PLANNING COMMISSION STAFF REPORT

September 13, 2016 Meeting

Second Floor Review 16-11
Floor Area Review 16-04

5037 Hill Street

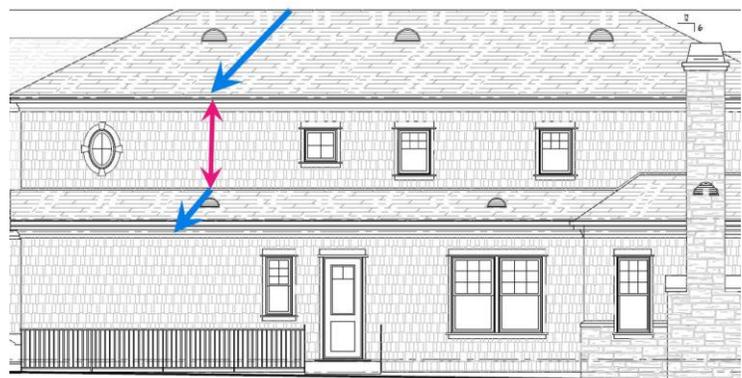
The home’s design is Traditional with Cape Cod influences. Beyond the recession of the 2nd-floor to the front and sides, the front elevation would be articulated by the curved living room bay, stately front porch and subtle projection of the upper volume space bay. Texture and detail are also evident in the use of shingle-siding throughout and a stone wainscot to the front.

At 29 feet, the structure’s height would be well within code limits. The lack of varied 2nd-floor setbacks to the sides is compensated by the pitch and height of the hips; the primary impression would be that of the roof’s sloped form, as opposed to a more rigid vertical form that could result from taller facades (highlighted above). Window size

would be decreased noticeably at the 2nd-floor level. The proposed array is sensible and proportionate to the respective interior space and not viewed as excessive or insensitive to neighboring properties.
